July 6, 2020

RE: Comet, LLC Site Plan Application

Comments from Ben Frost, Chairman, Warner Planning Board

LAYOUT AND MATERIALS PLAN
 CS1001

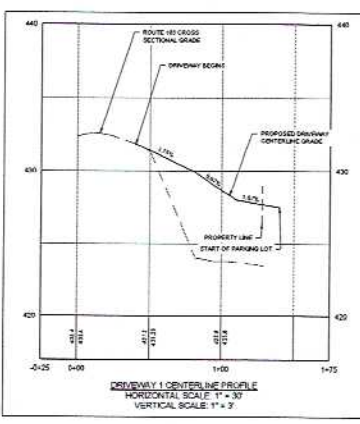
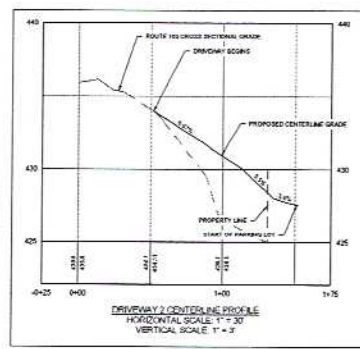
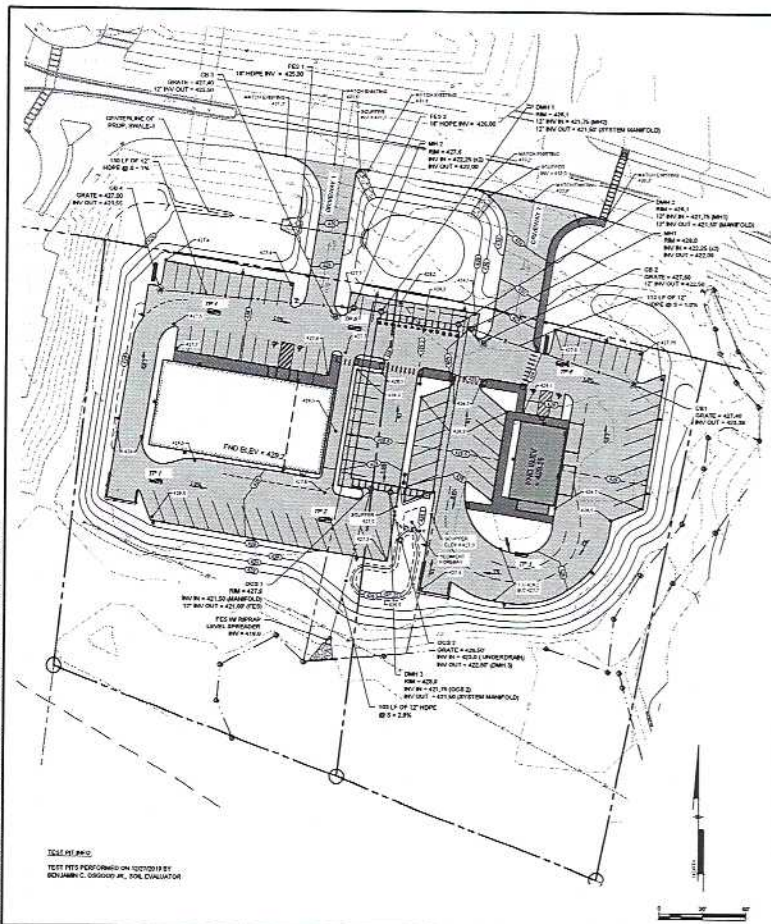
1. A revised copy of the site plan application will be provided.
 2. The plans have been submitted to NH DOT but no response has been received. The distance between the existing Sunoco and the right turn in driveway is 160' as shown on sheet CS1001.

LANDSCAPE & LIGHTING PLAN
 CS7001

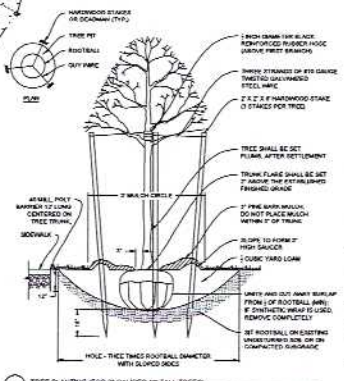
- Sheet 2 Notes
 - B. 6 inches of top soil – conflicts with Sheet 14, which says 4 inches (2 places); correct sheet 14 to indicate 6 inches. **Change will be made**
